## ORIGINATION FORM

### Proposed Revisions to a Standard Plans Index (Please provide all information — Incomplete forms will be returned)

Index Number: 700-030

Index Title: Mounting Exit Number Panels to Signs

MOUNTING EXIT NUMBER PANELS TO SIGNS

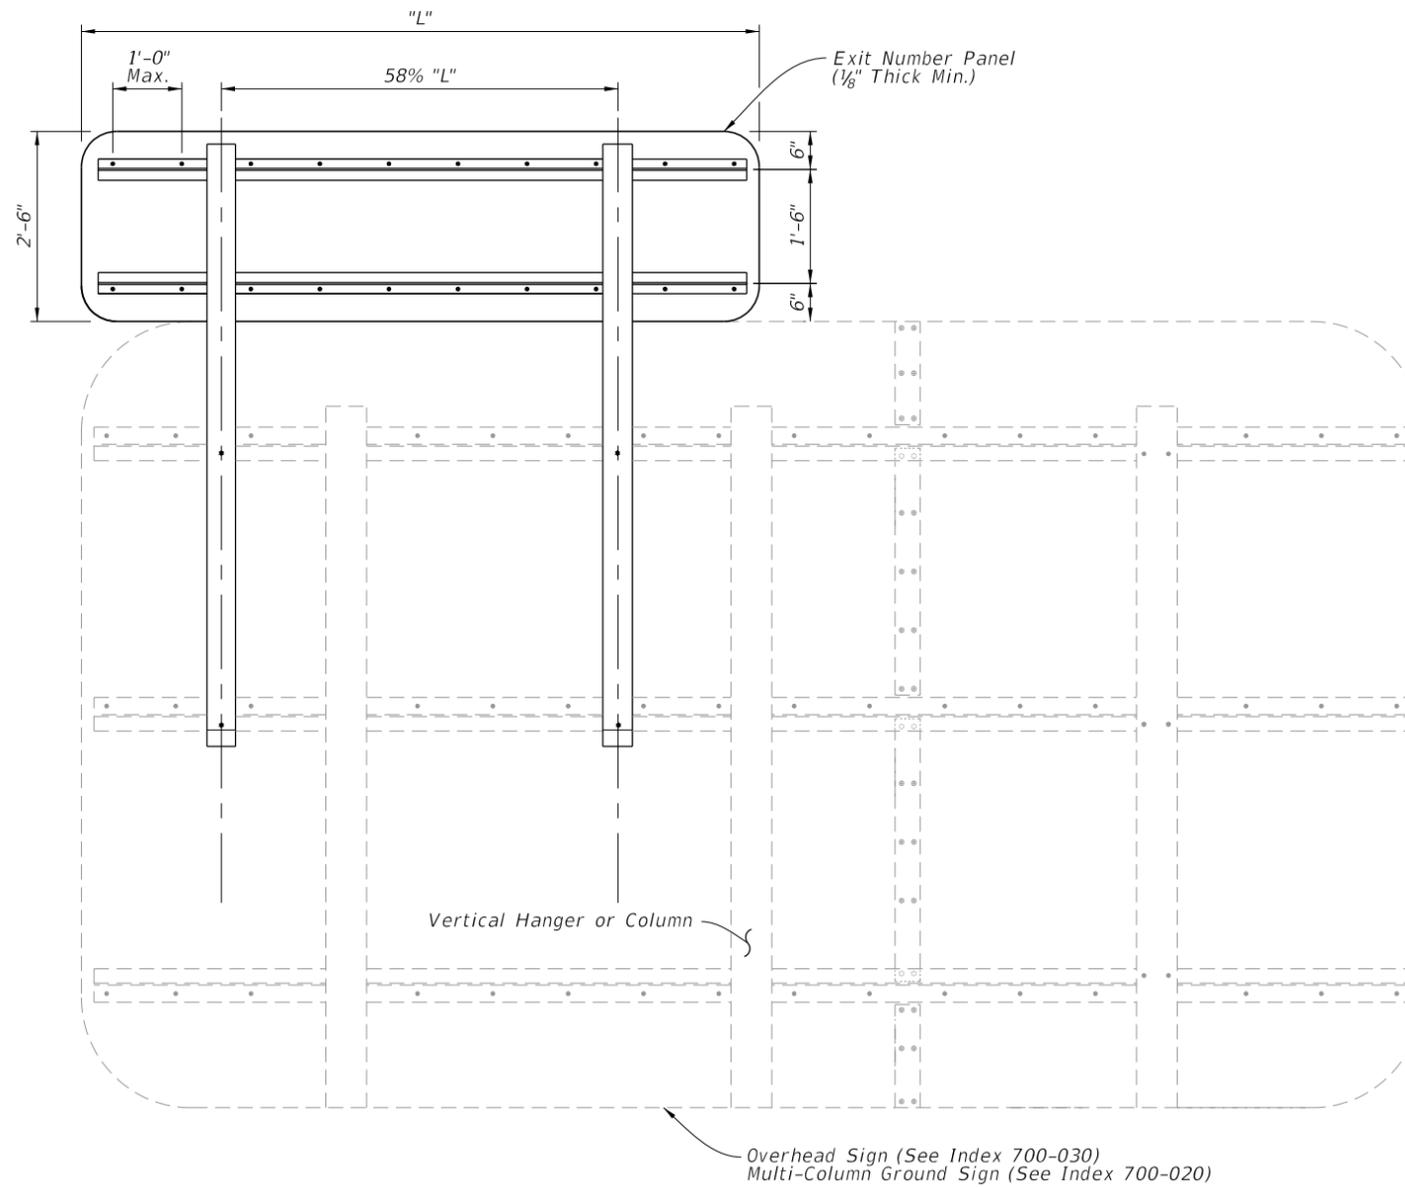
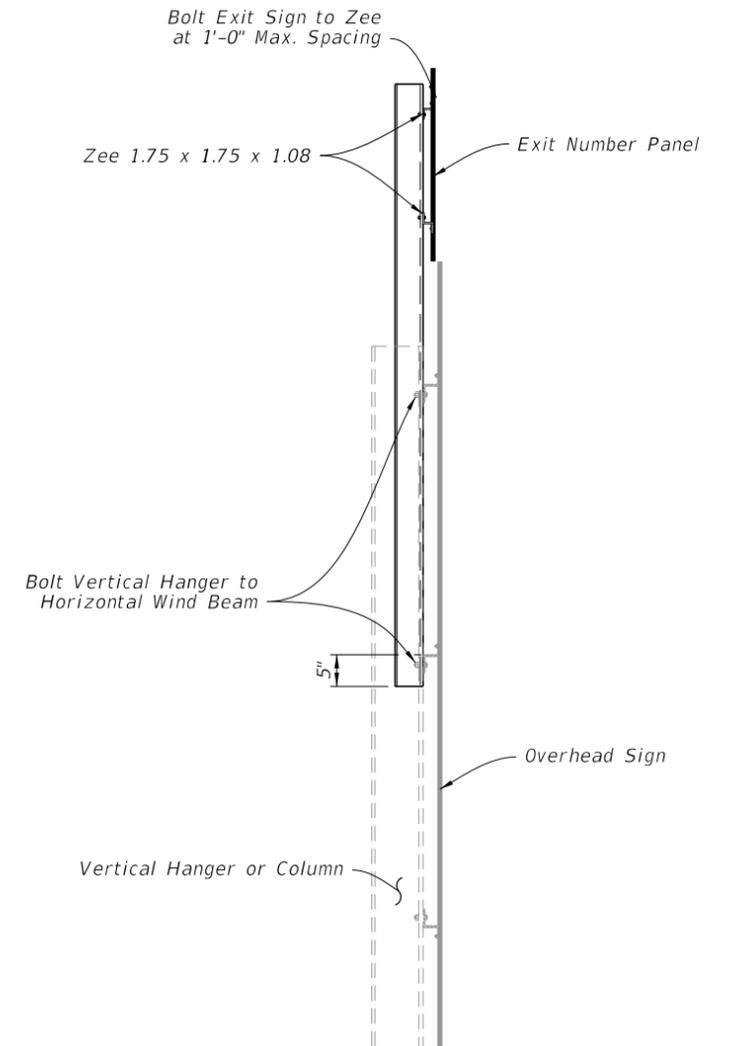
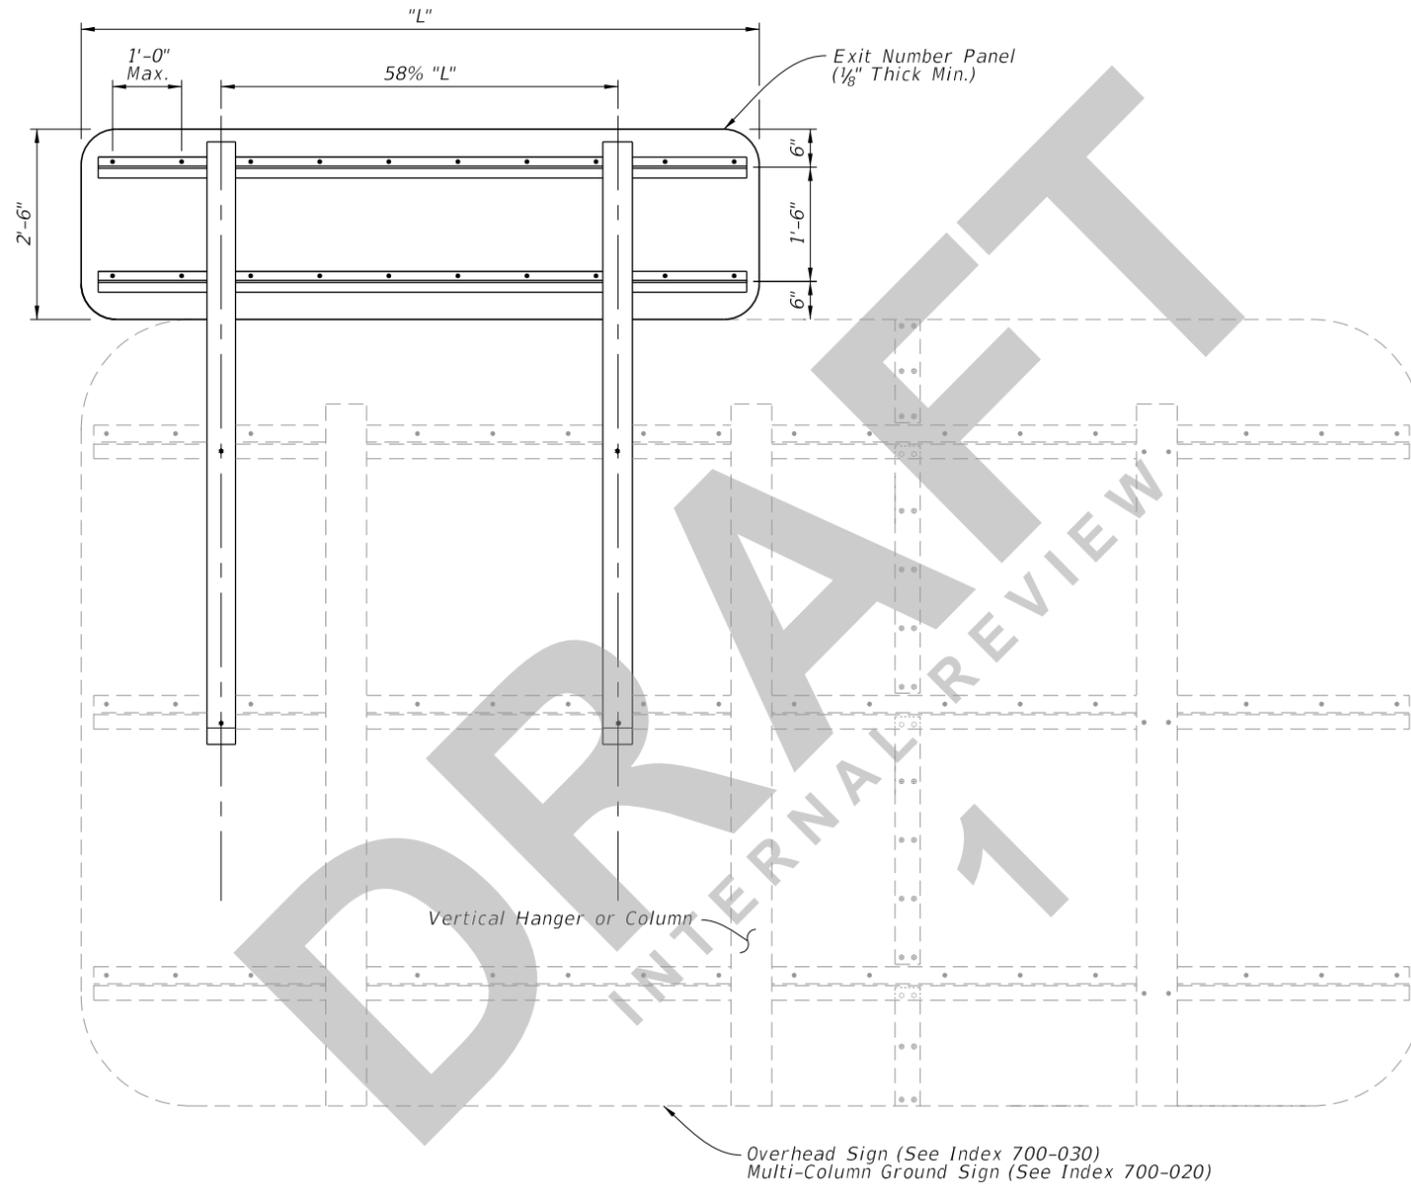
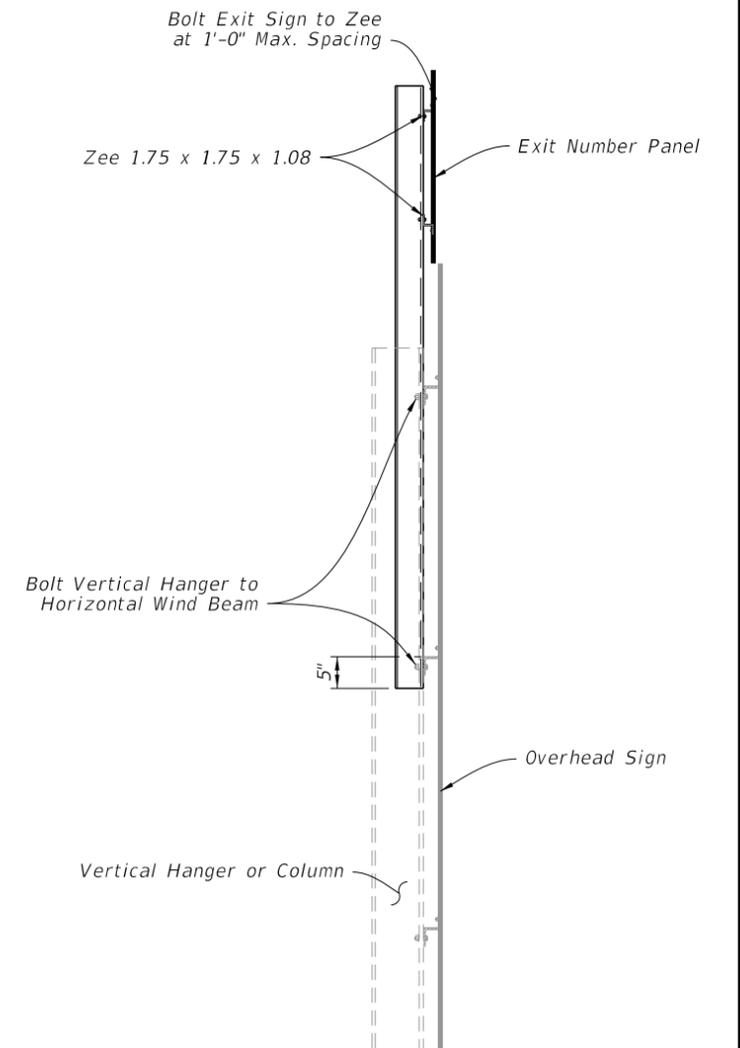
Change Note 2.B reference to ASTM B308 to ASTM B221 throughout Standard Plans as an administrative change.

1. Work with Indexes 700-020 and 700-030.
2. **Materials (Aluminum):**
  - A. Sheets and Plates: ASTM B209 Alloy 6061-T6
  - B. Standard Structural Shapes: ASTM ~~B308~~ Alloy 6061-T6
  - C. Extruded Shapes: ASTM B221 Alloy 6061-T6
  - D. For Bolts, Nuts, and Washers requirements see Index 700-020 or 700-030.
3. **Fabrication:**
  - A. See sign layout sheet for dimension "L" and sign face details in the Plans.
  - B. Round all sign corners.
4. For right exits, install the Exit Numbering Panel to the top right side of the Highway Sign.
5. For left exits, install the Exit Numbering Panel to the top left side of the Highway Sign.

B221

1. Work with Indexes 700-020 and 700-030.
2. Materials (Aluminum):
  - A. Sheets and Plates: ASTM B209 Alloy 6061-T6
  - B. Standard Structural Shapes: ASTM B221 Alloy 6061-T6
  - C. Extruded Shapes: ASTM B221 Alloy 6061-T6
  - D. For Bolts, Nuts, and Washers requirements see Index 700-020 or 700-030.
3. Fabrication:
  - A. See sign layout sheet for dimension "L" and sign face details in the Plans.
  - B. Round all sign corners.
4. For right exits, install the Exit Numbering Panel to the top right side of the Highway Sign.
5. For left exits, install the Exit Numbering Panel to the top left side of the Highway Sign.
